ADDENDUM NO. 4

CONSTRUCTION SPECIFICATIONS
FOR
UPPER EAST FORK CAVE CREEK CHANNEL
FCD CONTRACT NO. 90-54

ADDENDUM NO. 4

August 29, 1991

FIGURE 2 - BOX ATTACHMENT DETAIL (AS REVISED PER ADDENDUM NO. 1)

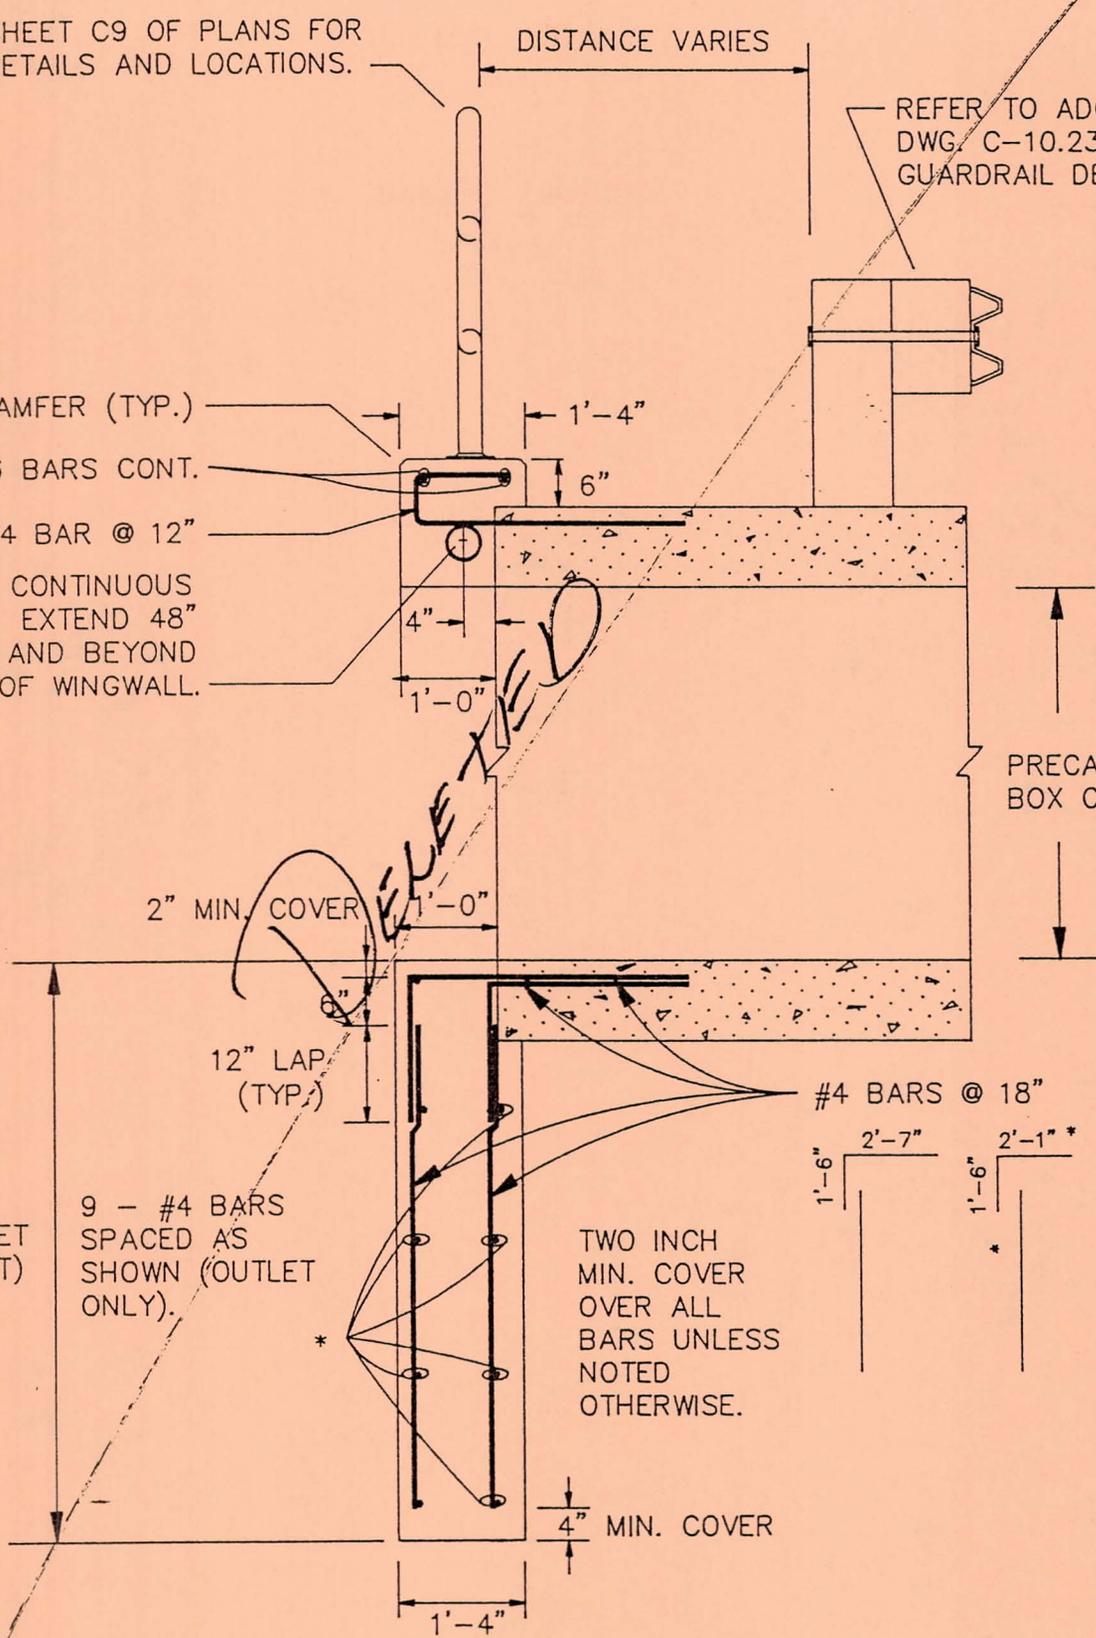
CHANGE the last sentence of the second paragraph under A. General to read:

"Welded wire reinforcing for factory precast boxes shall be as indicated in Table 1 and Figure 1 of the ASTM Designation C-850."
